DEPARTMENT OF THE AIR FORCE
AIR FORCE CIVIL ENGINEER CENTER

Subject: Response to WAFB – ADEQ Comments – ST012 – Discussion toward Extending Steam Enhanced Extraction, Bioremediation (EBR) Transition, Former Williams Air Force Based, Mesa, Arizona.

The ADEQ comments from the 11 February 2016 are repeated below followed by responses in italics.

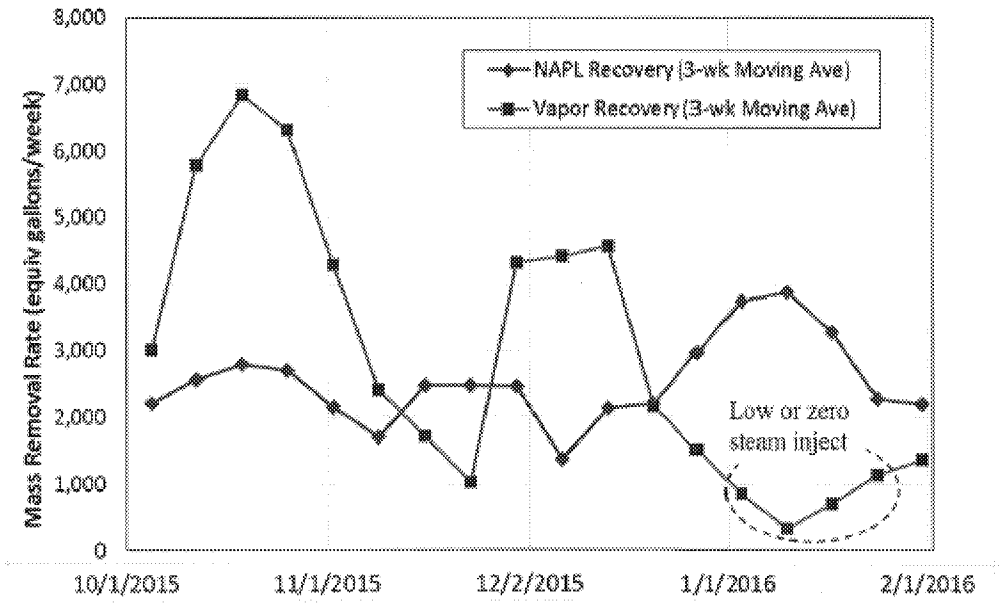
ADEQ asserts the mass removal criteria for transition to EBR has not been achieved. Data from weekly progress reports were plotted to show the average gallons of NAPL recovered each week starting in October 2015. Equivalent gallons of NAPL recovered in the vapor phase were also plotted and the results are illustrated below. The NAPL recovery rate (red) has not decayed over the last four months, consistently averages over 2,000 gallons per week, and no indication of decay is evident. The vapor recovery rate (blue) illustrates a general decay; however, the rate dropped when the steam injection was lowered and ceased at the beginning of January. This drop in vapor recovery with steam cessation indicates significant mass continues to be recovered from within the TTZ by steam injection and that mass recovery rates continue to be related to steam injection.

As stated in the Work Plan, the actual site specific removal rate curve will be evaluated to confirm or adjust the appropriateness of 10% of maximum to represent a condition of diminishing returns. The plan further states, continued operation below the 10 percent of peak removal rate may be implemented depending on the significance of continued mass removal, the status of Contaminant of Concern (COC) concentrations (e.g., benzene) in extracted fluids, and the need/ability for EBR to achieve further degradation based on data collected during the EBR field test.

Response: The mass removal data as presented in the weekly reports can create confusion for this type of analysis. Vapor mass removal includes both wellfield vapor mass as well as volatilized contamination from liquid treatment systems (tank vents and air stripper off gas). The turbulent flow encountered in the extraction system may also promote contaminant phase changes between the extraction wells and the treatment system. Vapor mass removal from the weekly reports can be affected by the latest available laboratory data. Vapor mass removal rates are calculated in the weekly reports based on the most recent available laboratory data. When new data is received, vapor mass removal calculations are adjusted back to the sample date but mass removal totals in previous weekly reports are not corrected and reissued. Finally, NAPL removal in the weekly reports is based on the total NAPL transferred to the storage tanks during the week divided by seven days. When NAPL is apportioned equally between days since the previous transfer it results in a slightly different NAPL removal rate.

These combined factors introduce errors using the data from the weekly reports in as described in the comment. The information presented in the BCT calls and meetings are a better representation of mass removal for making the type of evaluations described in this comment. The actual mass removal calculation spreadsheet has been provided (email from Don Smallbeck to BCT members on 4 March 2016) with data and mass removal calculations through the end of February.

With respect to the consistency of mass removal over several months, the adjustments made to continue to improve mass removal have likely contributed to the slow overall change in mass removal rates. Also, pressure cycles prior to the January depressurization were not coordinated across all three zones simultaneously, which may have hidden some of the mass removal fluctuations during earlier pressure cycles.
